**REGION OF WATERLOO**

**TO:** Chair and Members of the Ecological and Environmental Advisory Committee

**DATE:** January 30, 2007 **FILE CODE:** DO4-20058/DA

**SUBJECT:** **Proposed Butler Pit Extension, 1180 Cedar Creek Road, North Dumfries Township, Gilholm Marsh Environmentally Sensitive Policy Area [ESPA 58]**

Figure 1. Revised Butler pit proposed expansion relative to ESPAs 57 & 58. Extraction limits shown in black outline.  
(2006 imagery)

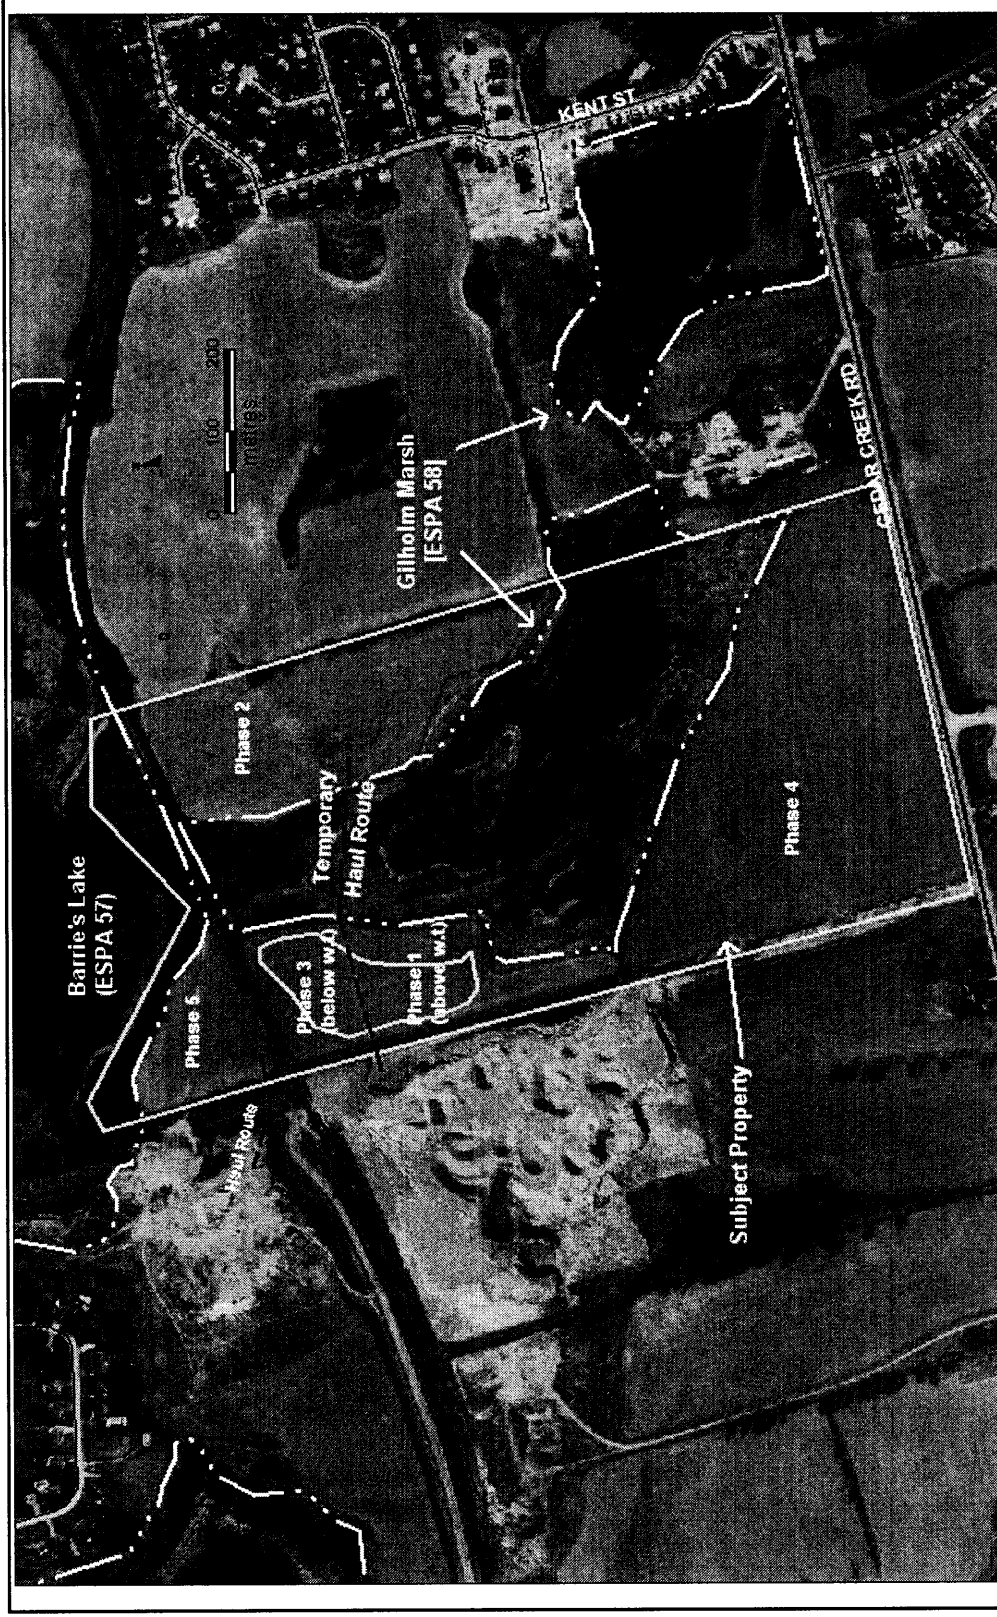
Two ESPAs are "contiguous" this property according to the definition in the Glossary of Terms (Regional Official Policies Plan, September 2006 Consolidation). Gilholm Marsh ESPA (ESPA 58) covers a substantial portion of the property (Figure 1) and also extends off site to the south-east. It enters the property south of centre on the east side and extends north-west almost crossing the property before veering northwards as far as, and ending at, the CPR line. The lake of Barrie's Lake ESPA (ESPA 57) lies to the north of, and adjacent to the property. Thus, the two ESPA's are effectively contiguous, with only the single-track CPR line between them. The wetlands of both ESPA's are also Provincially Significant Wetlands. ESPA 58 on the subject property also forms the southerly tip of the Blair-Bechtel-Cruickston Environmentally Sensitive Landscape.

It is important to note that the area under consideration is no longer identical to that discussed in the previous EEAC report (EEAC-05-012); the northern extent of the subject property, north of the CPR line, i.e. the triangular parcel of land (Phase 5, Figure 2) adjacent to Barrie's Lake ESPA (ESPA 57), has been sold and is no longer included in the proposed area to be licensed. In addition, the removal of material below the water table is no longer being considered in the revised proposal. The attachment Figure 1 shows the current layout of the proposed expansion of the extraction area; Figure 2 is the previous layout.

In accordance with Regional policies prohibiting extraction within ESPA's, extraction is being proposed only on those areas of the property which lie outside ESPA 58. The configuration of the Gilholm Marsh divides the proposed extraction area into three parts identified by phase numbers (Figure 1).

- 1.1 That the refined boundary of the Gilholm Marsh ESPA be staked in the field to the satisfaction of Regional staff and reflected on the site plan for the proposed gravel pit.;

- 1.5 That areas where sedimentation could occur into the ESPA be identified during the boundary staking process and that the site plan identify such areas and specify appropriate erosion and sedimentation control measures, preferably the construction of earthen berms designed to address this potential risk;
